# UNITED STATES PATENT AND TRADEMARK OFFICE

| APPLICATION NO. | FILING DATE | FIRST NAMED INVENTOR | ATTORNEY DOCKET NO. | CONFIRMATION NO. |
|-----------------|-------------|----------------------|---------------------|------------------|
| 10/815,785      | 04/02/2004  | Nicola Leone         | T8-467921US         | 9935             |

*Office Action Summary*

Krauser, 7,774

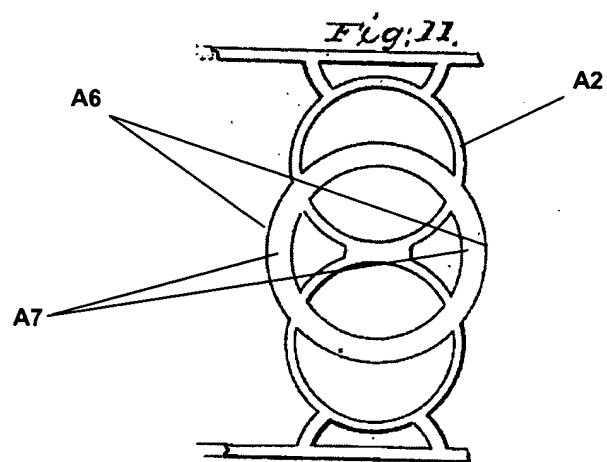
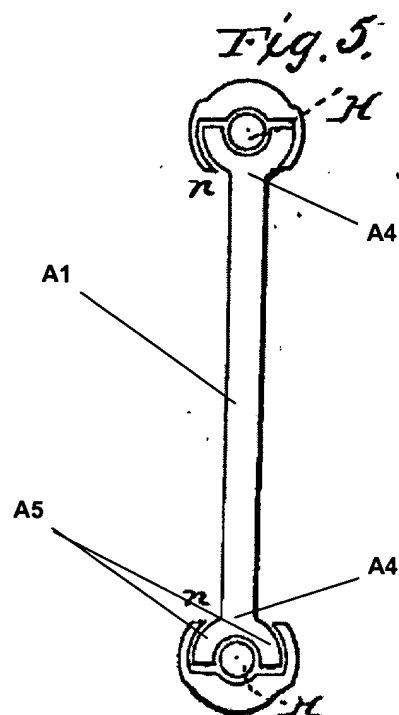
Regarding claim 1, Krauser discloses, in Figure 1, an ornamental insert comprising a body **A1** having a perimeter **A2**, and brackets **n** projecting from the perimeter **A2** from diametrically opposite sides **A4** of the body **A1**. Each of the brackets **n** has a pair of opposed sidewalls **A5**.

Regarding claim 2, the body **A1** has abutment surfaces **A6** formed on the perimeter **A2** on diametrically opposite sides **A7** of the body **A1** between the brackets **n** and equi-spaced from the brackets **n**.

Regarding claim 3, the body **A1** is selected from the group consisting of circular, astroidal, diamond-shaped, cross-shaped, and elliptical-shaped inserts.

Regarding claim 4, Krauser discloses, in Figure 1, an ornamental insert comprising a body **A1** having a perimeter **A2**, and brackets **n** projecting from the perimeter **A2** from diametrically opposite sides **A4** of the body **A1**. Each of the brackets **n** has a pair of opposed sidewalls **A5**. The body **A1** has abutment surfaces **A6** formed on the perimeter **A2** on diametrically opposite sides **A7** of the body **A1** between the brackets **n** and equi-spaced from the brackets **n**. However, Krauser discloses the abutment surfaces **A6** being rightward and leftward and the brackets **n** projecting vertically from the perimeter. Applicants should note that the limitations “upwardly” and “downwardly” are relative terms that orienting the insert 90 degrees from vertical will place the abutment surface upward and downward and the bracket will project horizontally from the perimeter.

Hainsworth, 386,124

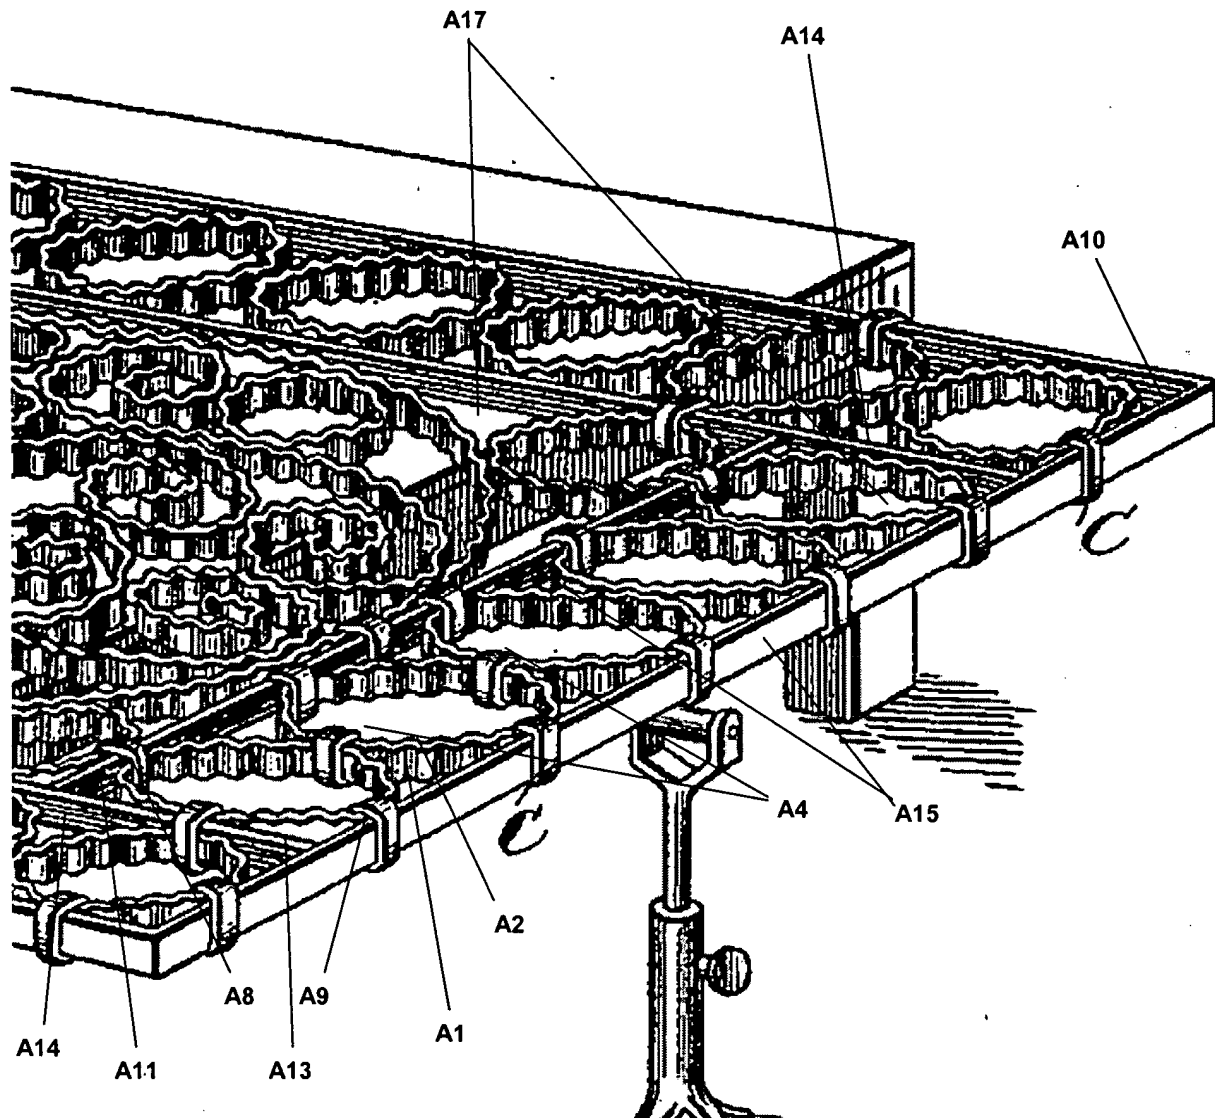
Regarding claim 4, Hainsworth discloses, in Figure 3, an ornamental fence insert comprising a body **A1** having a perimeter **A2** and brackets **C**. An upwardly facing abutment surface **A8** and a downwardly facing abutment surface **A9** are formed on the perimeter **A2**. The brackets **C** project outwardly and horizontally from the perimeter **A2** of diametrically opposite sides **A4** of the body **A1**. Each of the brackets **C** has a pair of opposed sidewalls **A5** defining a u-shape.

Regarding claim 5, the upwardly facing abutment surface **A8** is seated on a rail top surface **A10** and the downwardly facing abutment surface **A9** is in abutment with a top rail bottom surface **A11**.

Regarding claim 6, the sidewalls **A5** are joined by a web **A12**.

Regarding claim 7, each of the sidewalls **A5** overlaps a surface **A13** of one picket **A14** in a direction of a horizontally extending direction of rails **A15**.

Regarding claim 26, Hainsworth discloses, in Figs. 1, 3, and 4, a trellis comprising a pair of parallel, spaced-apart rails **A14**, transverse equispaced pickets **A15**, and an ornamental insert (Fig. 3). The pickets **A15** extend between the rails **A14** and are joined to the rails **A14** defining rectangular openings **A17** with the rails **A14**. The insert comprises body **A1** having a perimeter **A2**, and brackets **C** project from the perimeter **A2** from diametrically opposite sides **A4** of the body **A1**. Each of the brackets **C** has a pair of opposed sidewalls **A5**.

Regarding claim 27, the openings **A17** are square (some are square and rectangular) and the insert is circular and has abutment surfaces (abutment surfaces are around the perimeter) formed on the perimeter **A2** on diametrically opposite sides of the body **A1** between the brackets **C** and equispaced from the brackets **C** about the perimeter **A2**.
